SUBJECT: RK SUBDIVISION SKETCH PLAN

Sketch Plan Review

Professional Engineering Consultants (PEC) reviewed the submitted Sketch Plan for the proposed RK Subdivision, located on Parcel 130319300014, on County Road 398 east of Wild Country RV Park.

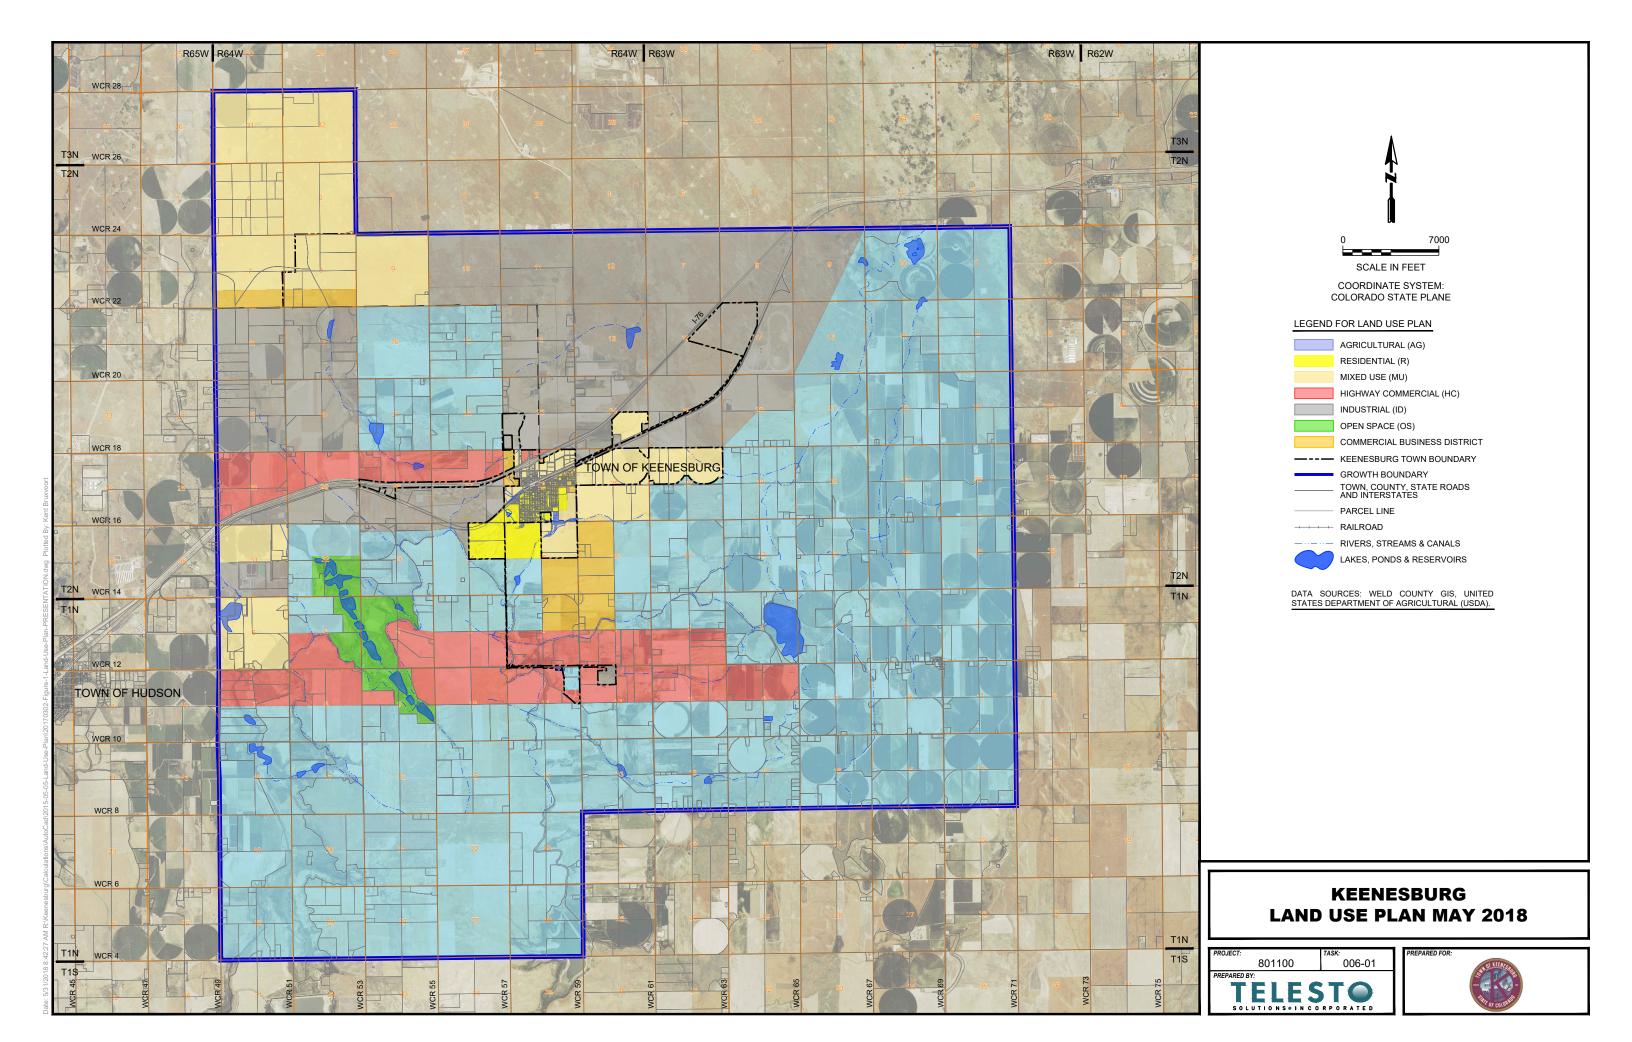
- 1. The Town would prefer that stormwater storage facilities be detention ponds rather than retention ponds.
- 2. Please consider an access from County Road 398 that intersects perpendicular to the road. This will provide safer exit to County Road 398.
- 3. With preliminary design, the Town will require a Traffic Study that projects traffic for the subdivision and considers existing traffic counts at the site. The Town can provide traffic narratives and studies that have recently been completed for nearby projects as supplementary information. The Traffic Study should evaluate whether auxiliary lanes to or from County Road 398 should be provided. Sight distance to the east should be addressed in the study.
